OBSERVATIONS ON THE ENDURANCE,  
CLARENCE AND MONARCH ALLUVIAL  
AREAS - MOUNT CAMERON, TASMANIA.MLs: 51m/73, 12m/76, 9m/76, 10m/76,  
11m/76R. Curtis,  
December, 1977

CONTENTS

B.M.I. MINING PTY. LTD. (LIABILITIES)	Blue Metal Industries Ltd
CLARENCE TO ORIGINAL AND ADDITIONAL LEAD	SCALE 1 INCH TO 50 FEET DRAWING NO. 22
	DATE
	BY
	APP'D

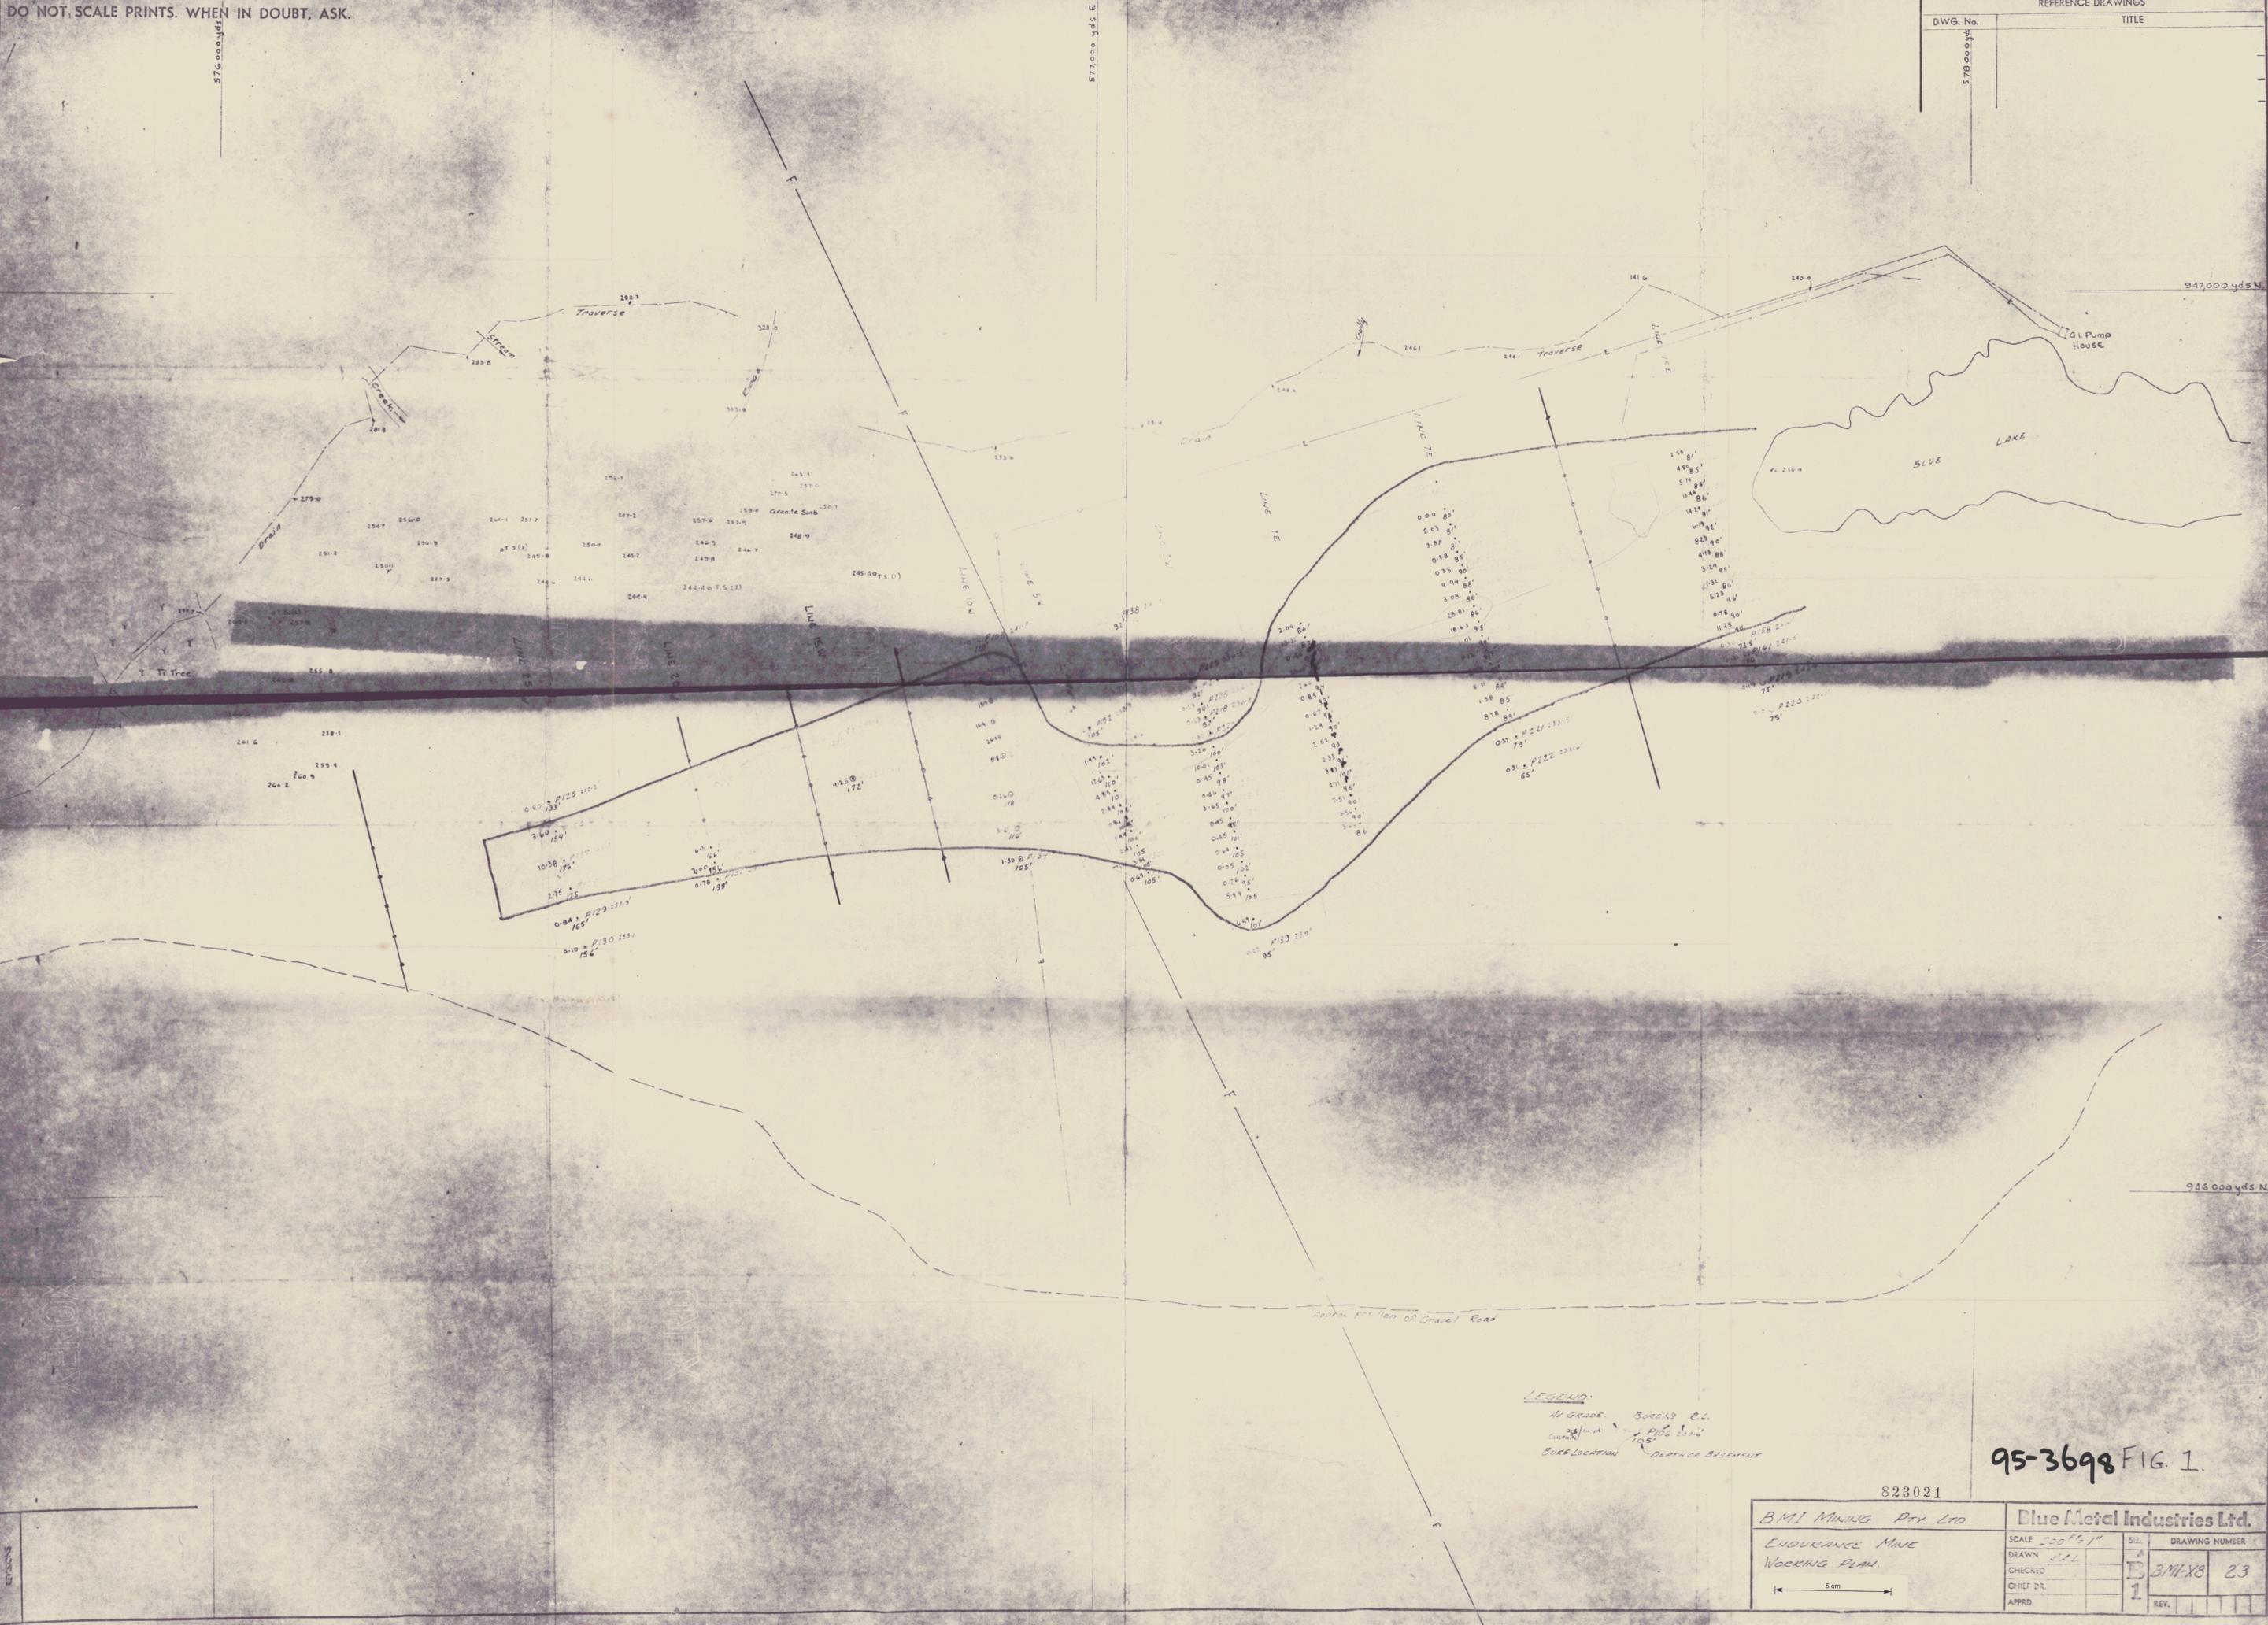
The reserves outlined from known drilling are shown on Figs 2 and 3. The calculation, details of which are given in Appendix II, amounted to 2,712,364 cu yds at 0.48 lbs SnO<sub>2</sub> or 0.35 lbs Sn per cubic yard. Again a planned check programme by B.M.I. was never carried out and subsequently the creek was dammed at the northern end of 6277M. This dam covers the major part of the deposit and the water extends back to the middle of 6285M. No attempt has ever been made to work the Clarence.

on the Clarence since the plans have figures which appear rounded off, such as  $\frac{1}{2}$ lb,  $\frac{3}{4}$ lb, 1lb etc as if the values have been brought to the nearest quarter pound.

The drilling on the Clarence is suspect and would require a check programme. Much of the deposit is in a channel defined by one or two samples and must consequently be narrow. Such channels are often boulder strewn. Check drilling on the major part of the deposit would require the draining of the lake.

95-3698 FIG. 1.

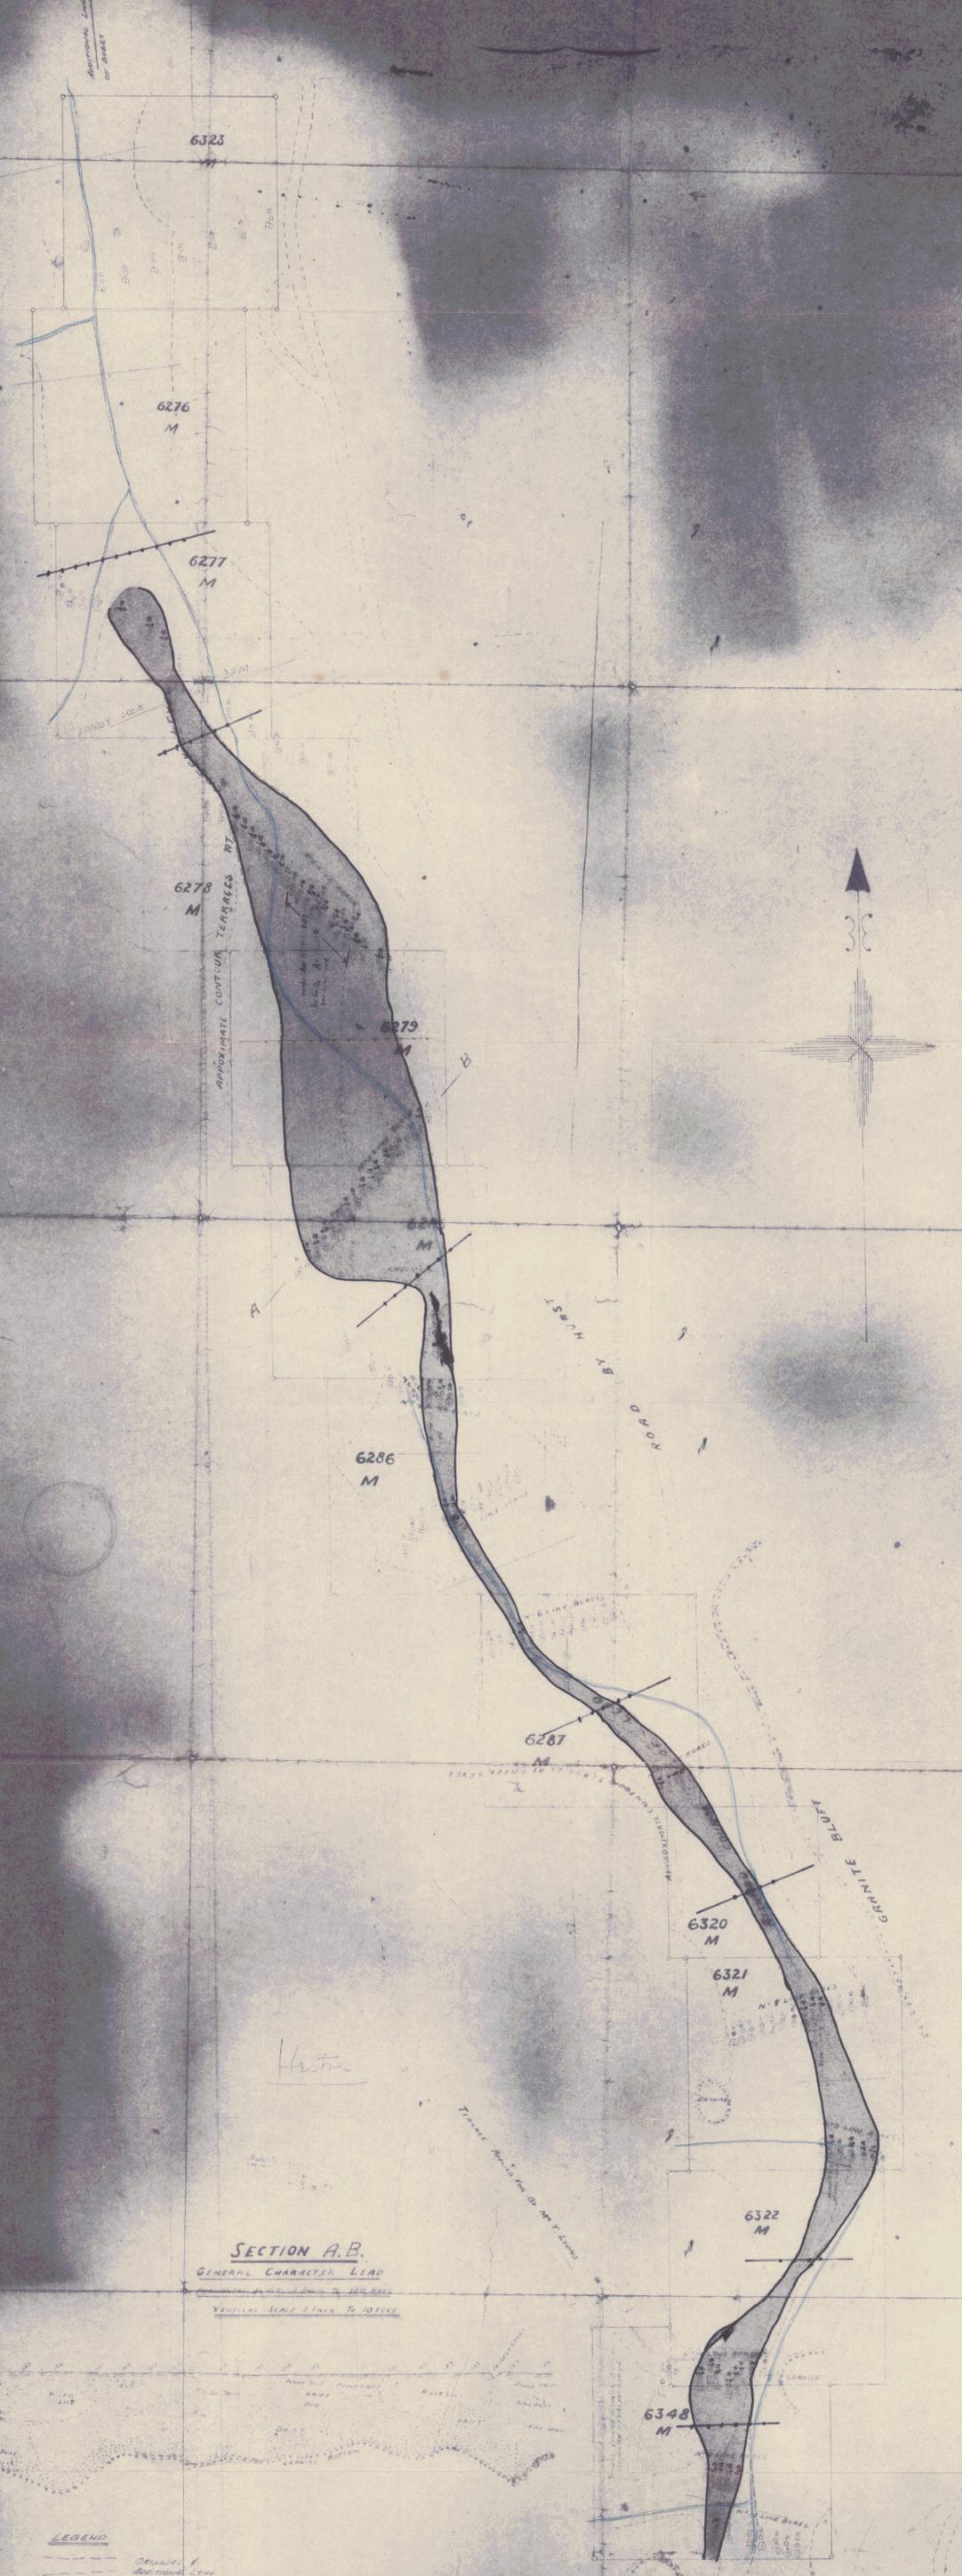
The outline of reserves drawn from known drilling is shown in Fig. I.

I have recalculated the reserves from this plan and come up with 10,920,626 cu yds of <sup>0.35 lb</sup> 5.69 ozs SnO<sub>2</sub> or 0.26 lbs Sn per cubic yard.

A programme of check drill holes set out by B.M.I. and located on Fig. I was never undertaken.
